Willow Rock Energy Storage Center (21-AFC-02)

DATA REQUEST RESPONSE SET 1B

Response to California Energy Commission Staff

TITLE
ATTACHMENT DR93-1 MAP

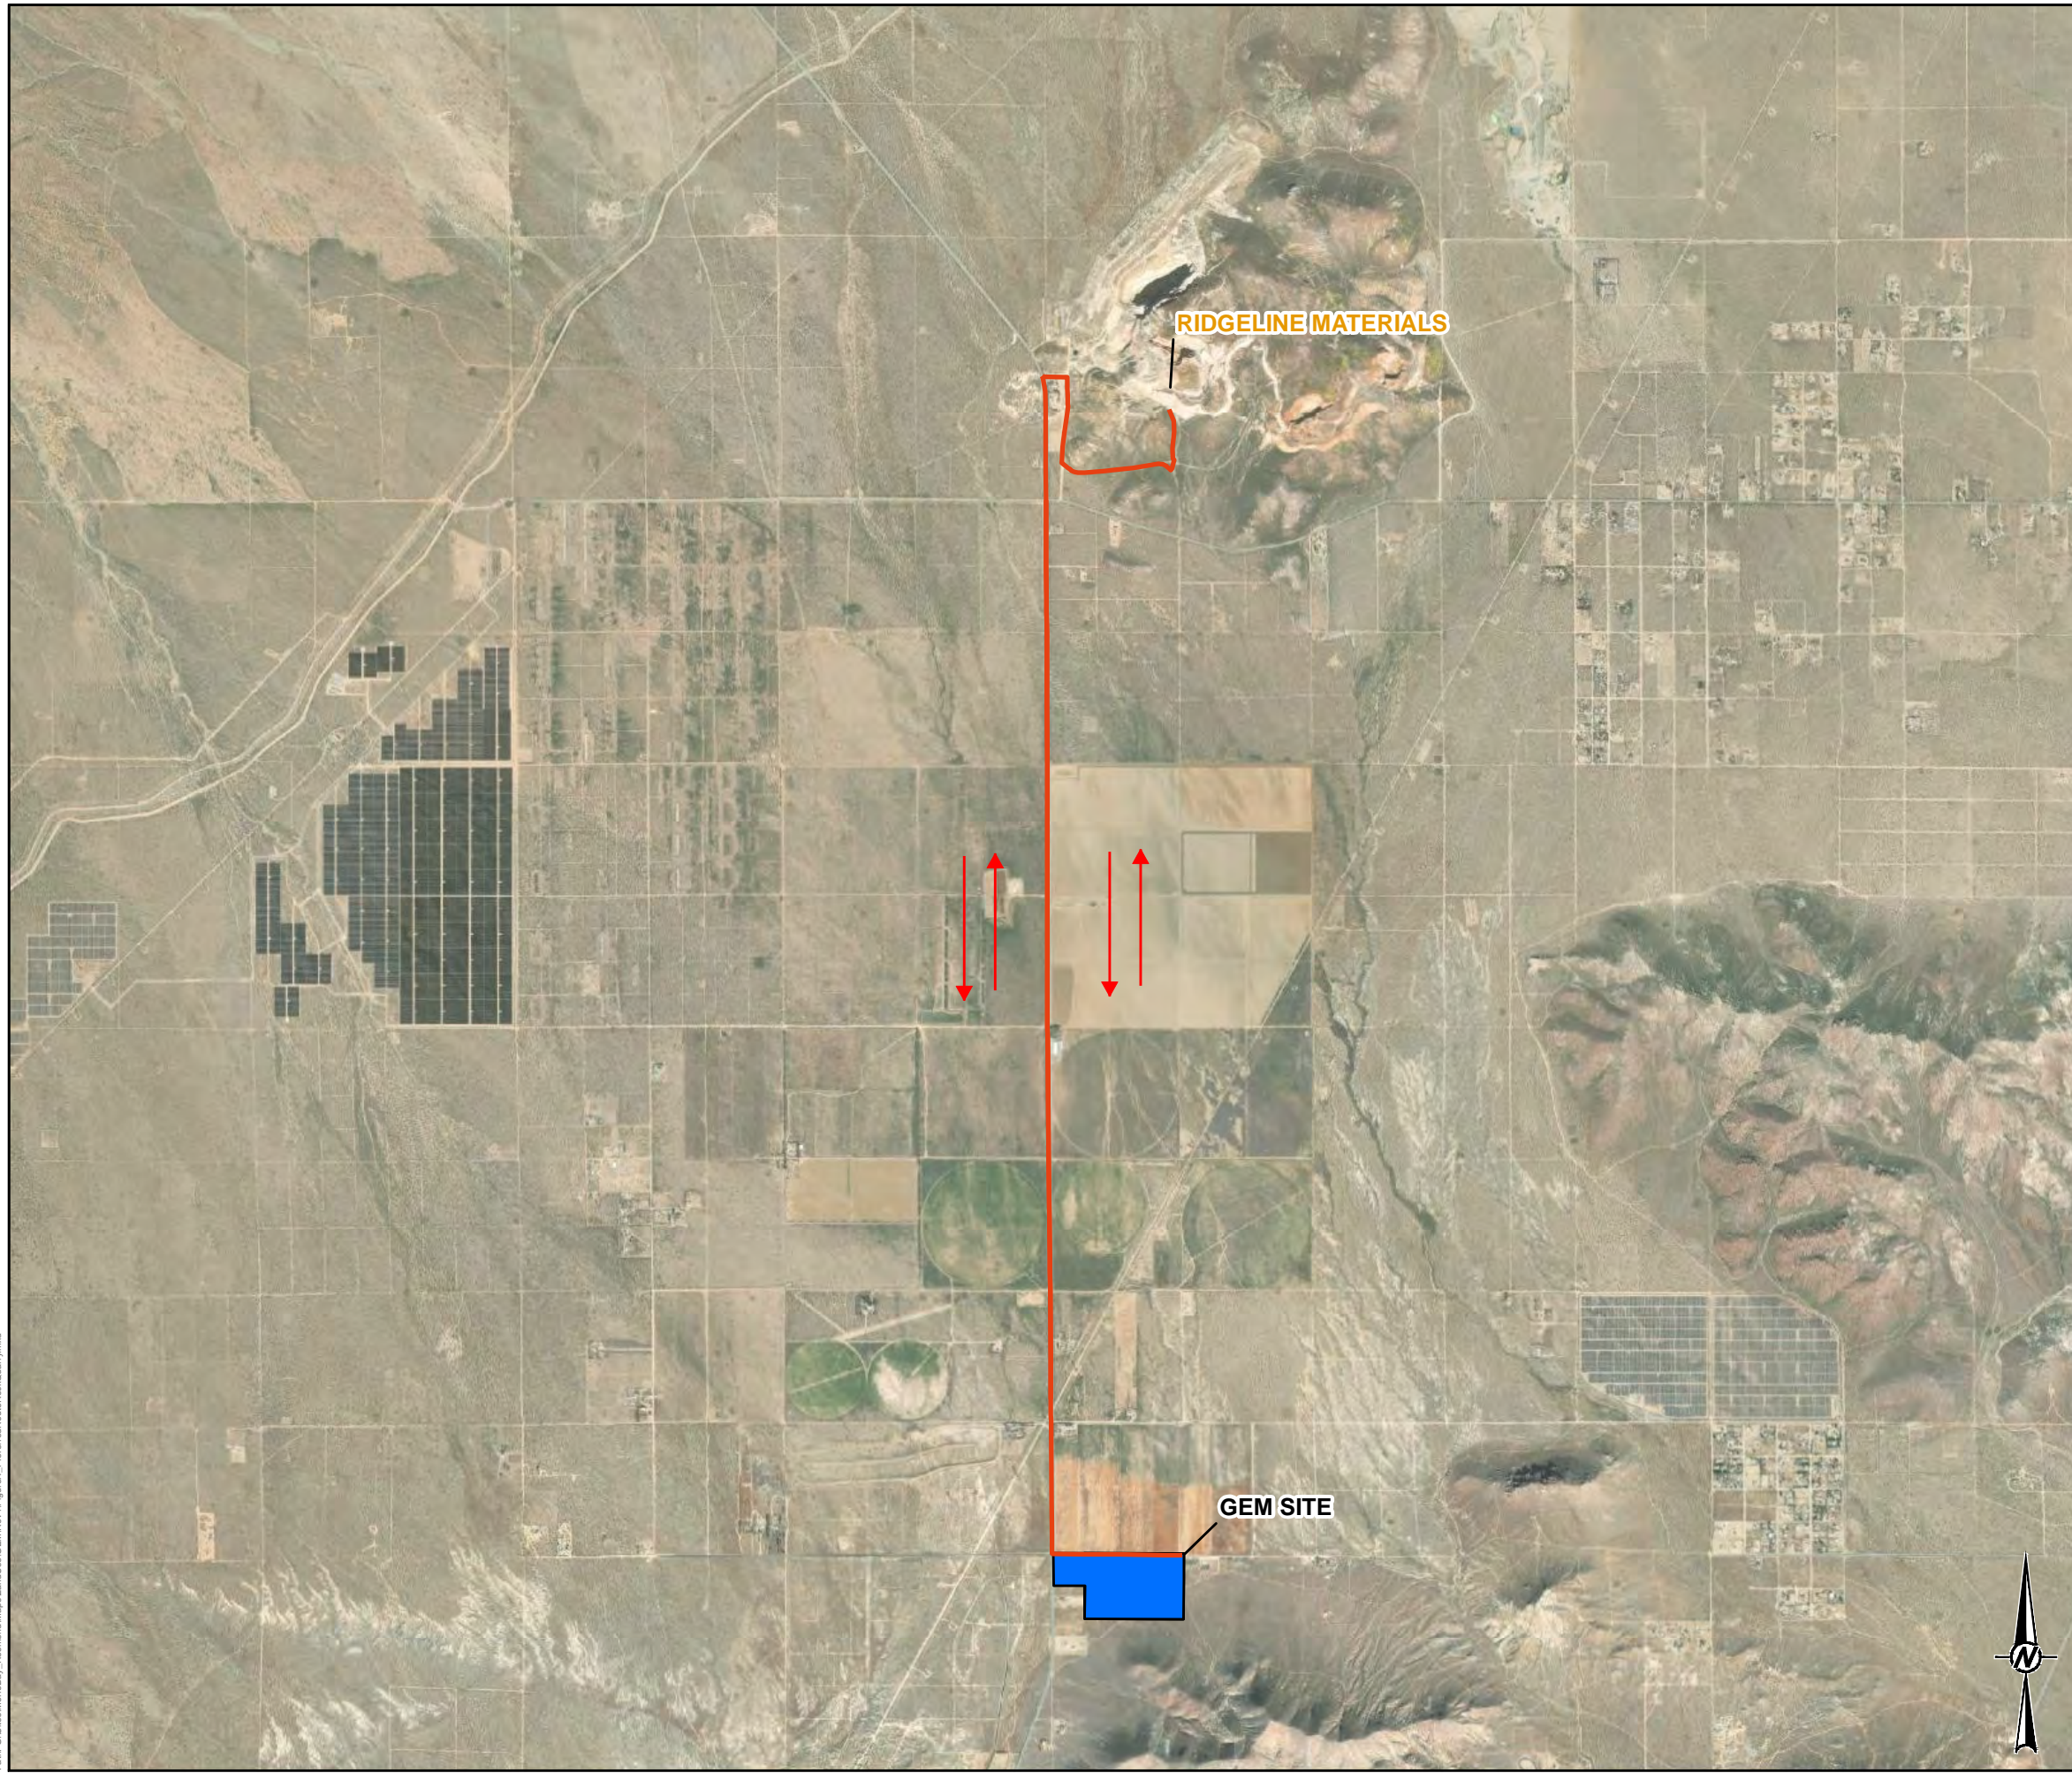
DR93: *Would all truck trips associated with the removal of the rock take the same route to the local rock quarry located five miles north of the project site? Provide a map showing the preferred route.*

Response: The preferred route to the local rock quarry located 5 miles north of the project is mapped in Attachment DR93-1. However, the Applicant is still exploring additional waste rock options.
